URGENT MEDICAL DEVICE CORRECTION

GE Healthcare

GEHC Ref# 32067

RE: Giraffe Bedded Warmer/Panda iRes Warmer - Bedside panels, latch areas may be cracked, broken or damaged.

Figure 1A: Bedside panels

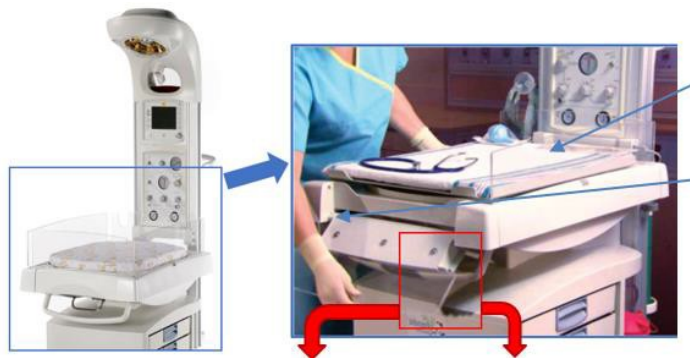
GE Healthcare has become aware that the bedside panels, and latch areas on the warmer can crack or break if the unit is moved using the bedside panels instead of the front handle or the maneuvering handle. If an infant impacts a bedside panel with a cracked or broken latch, the panel can disengage and fall open, no longer protecting the infant from falling from the warmer.

1) Inspect the warmer bedside panels (see below Figure 1A) latch areas and the areas connecting the panel to the bed (see below Figure 1B) for any cracks or damages per the addendum included in this mailing. **If any portion of the bedside panels or latches are cracked or broken (see below Figure 1C), stop use of the warmer.** Complete and return the attached response form in Table 1-1, indicating what components require replacement. If the Warmer bedside panels or latches (see below Figure 1D) have no cracks or damage, continue to Safety Instruction 2.

2) If the Warmer bedside panels or latches have no cracks or damage, you may continue to use your warmer. Apply Safety labels included in this mailing to the warmer by following the below instructions:

- a) Clean area with a cleaning solution recommended in the Operation and Maintenance Manual.
- b) Wait for the area to dry.
- c) Peel off label 1 and apply it to the front (south) bedside panel at the location shown in the illustration below.
- d) Peel off label 2 and apply it to the left (west) bedside panel at the location shown in the illustration below.
- e) Peel off label 3 and apply it to the right (east) bedside panel at the location shown in the illustration below.
